Memorandum
Department of Planning & Public Works

RE: **Saturn of West County (Long Road Crossing):** A Site Development Section Plan, Architectural Elevations, Landscape Plan and Lighting Plan for a 5.34 acre parcel zoned "PC" Planned Commercial located at the northwest corner of the intersection of Long Road and Chesterfield Airport Road.

Re: Saturn of West County (Long Road Crossing)
Response to Planning Commission Concerns

SECTION AT ATRIUM ENTRY

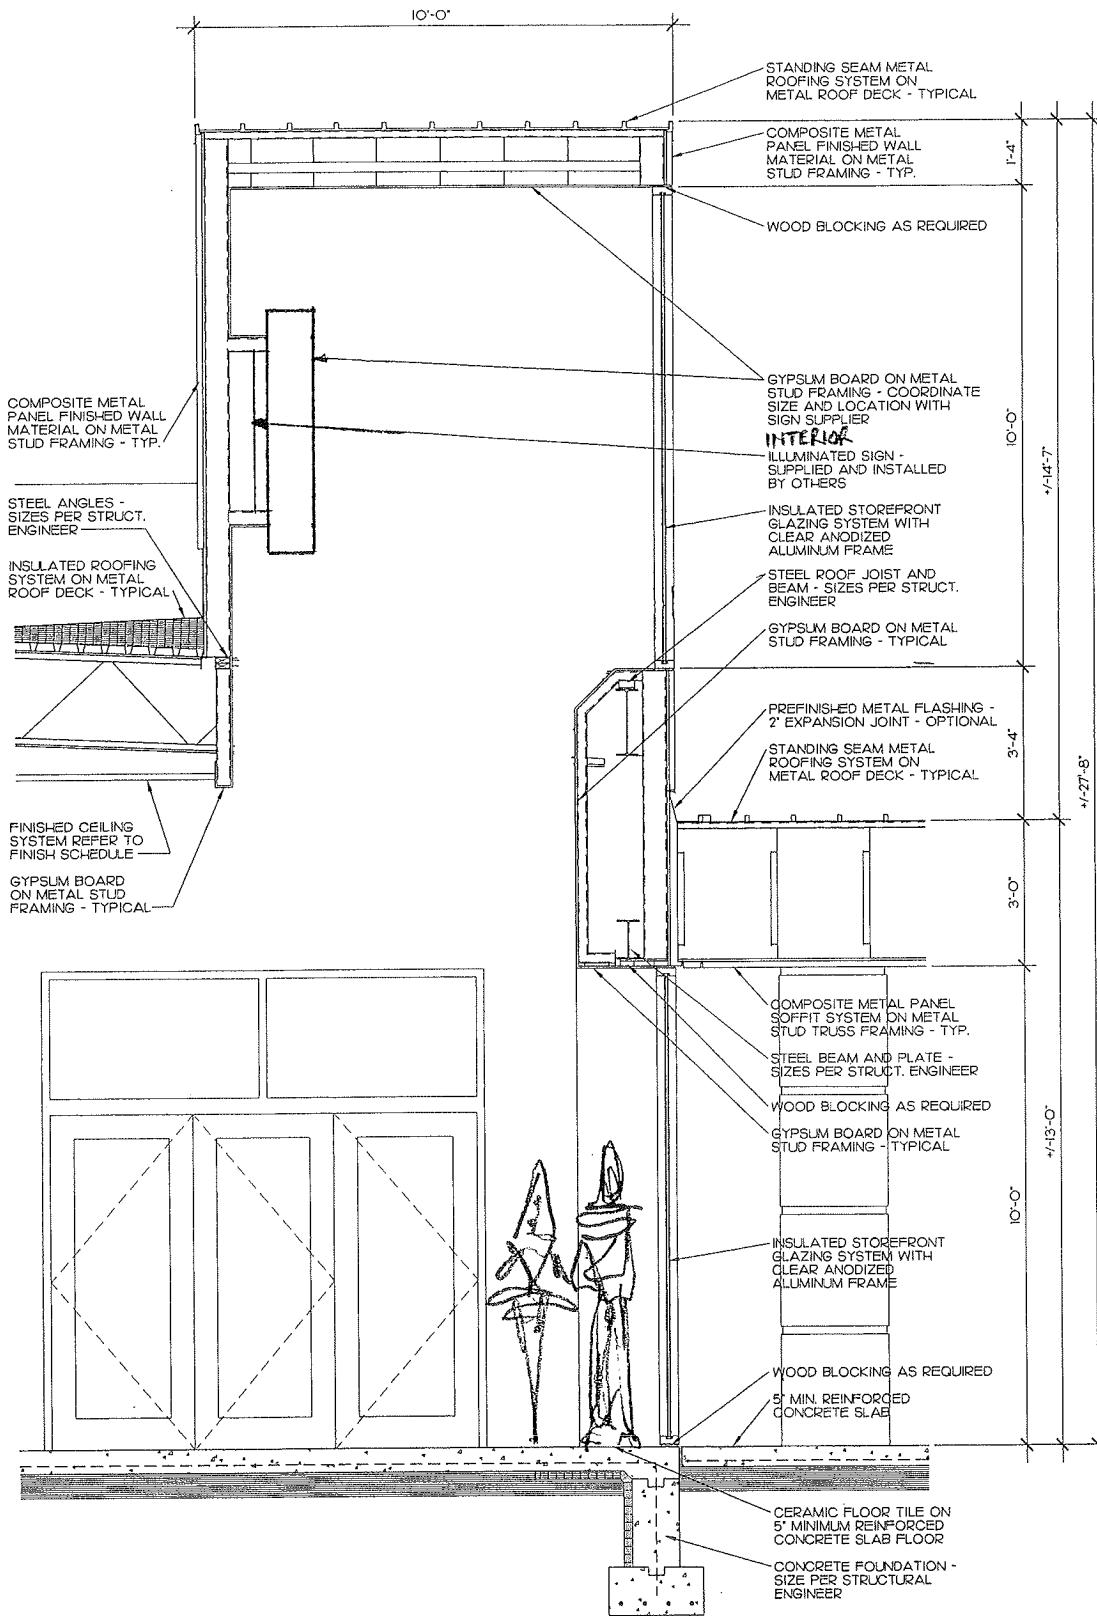
4. The purpose of this architectural feature is to create a distinctive and recognizable atrium entry element that directs our customers to the main entrance. Secondly, it also frames and highlights the interior window sign mounted on the rear inner wall of the Customer Entry Atrium (see attached section drawing). Our window box element is smaller, but conceptually the same as the window box and logo over the entry to the new Walgreen's drug store at the entrance to Long Road Crossing. We will submit the internal sign framed by the window box, as a "window sign" under the Chesterfield Sign Ordinance definitions and size requirements.

1 NORTH EXTERIOR ELEVATION
SCALE: 1/8" = 1'-0"

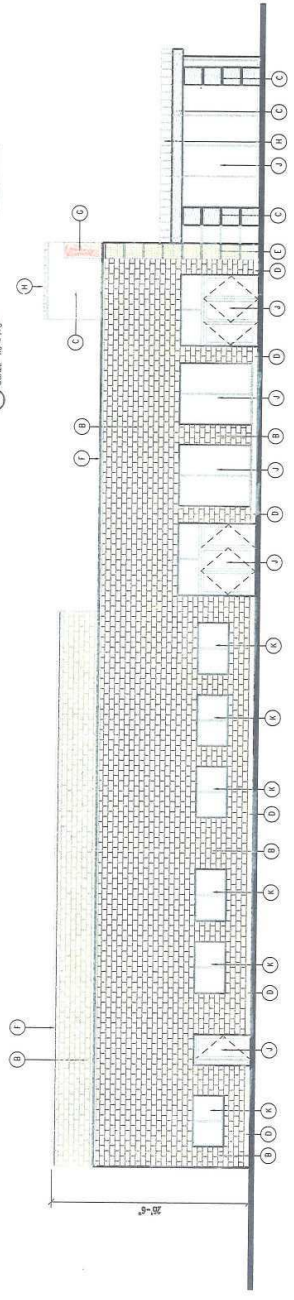
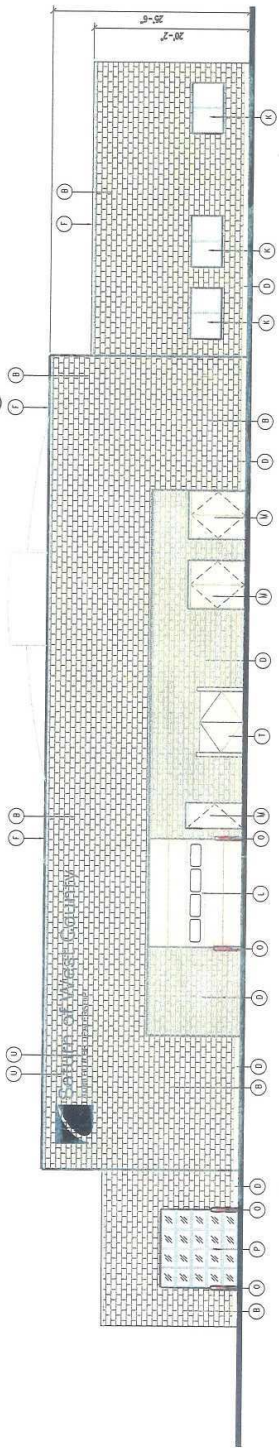
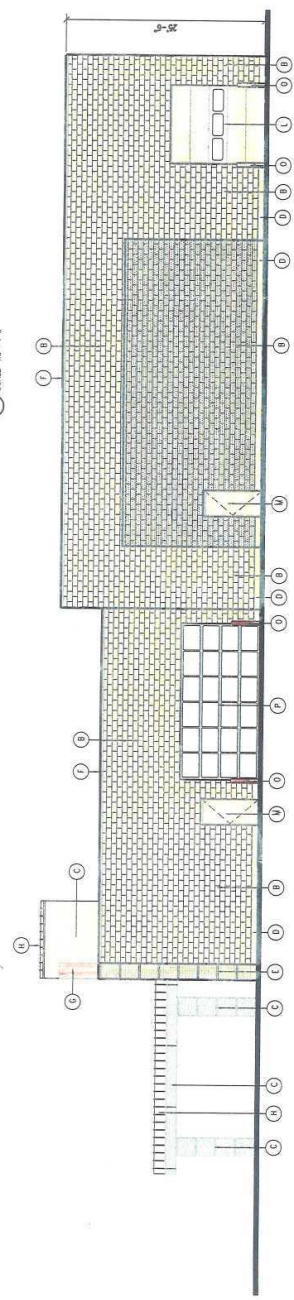
1. Increase the screening of the Service Reception doors facing Highway 46/64.
2. Change the color and material of the red, aluminum horizon on the north elevation.
3. What elements of the current design are necessary components of the Saturn brand? How do these elements compare to other developments in the Chesterfield Valley?
4. Please clarify the purpose of the window box on the north elevation.
5. How do the location and design of the proposed Service Reception doors compare with other car dealerships along Highway 40/64?

1. The corporate logo feature shown on a red field on both the northern and southern elevations constitutes additional signage and is inconsistent with other developments in Chesterfield Valley. Additionally, the Board is concerned about the proposal to illuminate this area.

2. We are unable to change the size, color or the material of this building element, due to our franchise requirements from Saturn.
3. Unchangeable elements of the Saturn brand for the front of the building include: The location and configuration of the customer entry, canopy and vehicle delivery module, the red horizon and window box element with the Saturn logo inside the lobby, the customer service reception doors and the color of the building.

L1

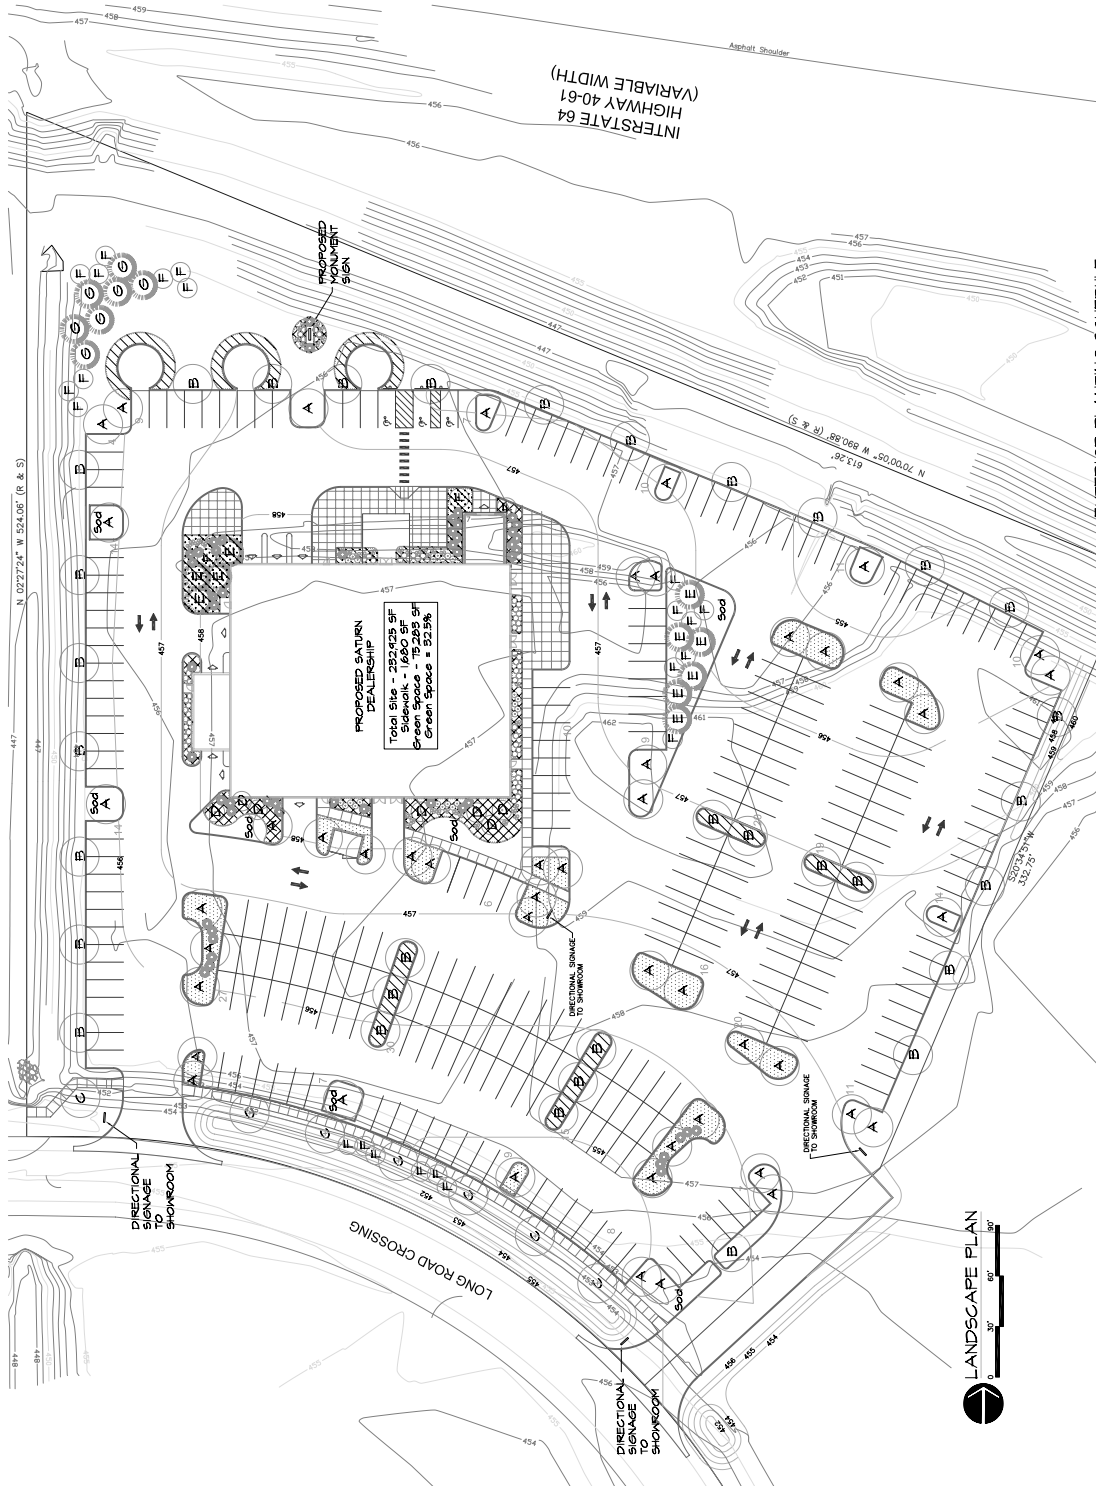
At the August 13, 2007 City of Chesterfield Planning Commission meeting the above-referenced matter was recommended for approval, with one amendment to the landscaping to provide a variety of evergreen trees, by a vote of 5-3. According to City of Chesterfield Ordinance 2351 which governs the development site, after approval of the site development section plan is recommended by the Planning Commission, this project will be forwarded to the City Council for final approval.

1. We are showing new evergreen and deciduous landscape screening (from the approved plant list) at the Northwest corner of the site. This new planting area will help screen the Customer Service Reception doors from the approach view of Eastbound US40/64 traffic. The doors will also have foreground screening from our required planting and the static car displays on the North side. We have also expanded an existing planting area directly west of the Customer Service Reception doors and added additional evergreen trees there. Keep in mind that from Westbound US40/64, there will be screening from the future Long Road off ramp and Long Road bridge reconstruction.
